Access Compliance Report

Public Rights-of-Way

(Curb Ramps)

Intersection ID: 10028610	Main Street: HONOR_GUARD_AV	Cross Street: N/A	Location: SE
ADA ID: DA68E3941E21	Ramp Type: BlendTrans1	Initial Pass/Fail: Fail	Overall Compliance: No
Codes/Mitigation Info/Possible Solution		Field Measurements/Component Compliance	
Severity Score: 30

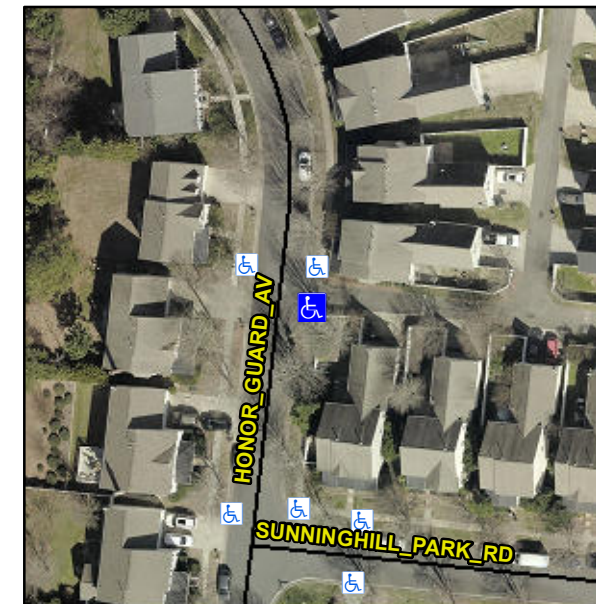
R304.5.1, R304.5.3

Compliance	Description	Data	Compliance	Description	Data
N/A	Ramp Length (in)	97.0	Yes	BlendTrans Slope (%)	1.5
No	Ramp Width (in)	32.0	No	BlendTrans XSlope (%)	5.9
N/A	Flare Type LT	N/A	N/A	Flare Type RT	N/A
N/A	Flare Slope LT (%)	N/A	N/A	Flare Slope RT (%)	N/A
N/A	Flare Traversable LT?	N/A	N/A	Flare Traversable RT?	N/A
N/A	Landing Length (in)	N/A	N/A	DWS Provided?	N/A
N/A	Landing Width (in)	N/A	N/A	DWS Contrast?	N/A
N/A	Landing Slope (%)	N/A	N/A	DWS Length (in)	N/A
N/A	Landing X Slope (%)	N/A	N/A	DWS Full Width?	N/A
N/A	Landing Curb? (Y/N)	N/A	N/A	DWS Offset (in)	N/A
N/A	Shared Landing?	N/A			
N/A	Gutter Ponding?	N/A	N/A	Gutter Slope (%)	N/A
N/A	Gutter Lip Ht (in)	N/A	N/A	Gutter X Slope (%)	N/A
N/A	Painted X Walk1?	No	N/A	Painted X Walk2?	No
	X Walk 1 Direction	To N		X Walk 2 Direction	To W
	X Walk 1 Width (in)	N/A		X Walk 2 Width (in)	N/A
	X Walk 1 Slope (%)	0.5		X Walk 2 Slope (%)	5.3
	X Walk 1 X Slope (%)	2.1		X Walk 2 X Slope (%)	2.0

Remove & Replace Curb Ramp With Two New Directional Ramps or Equivalent.
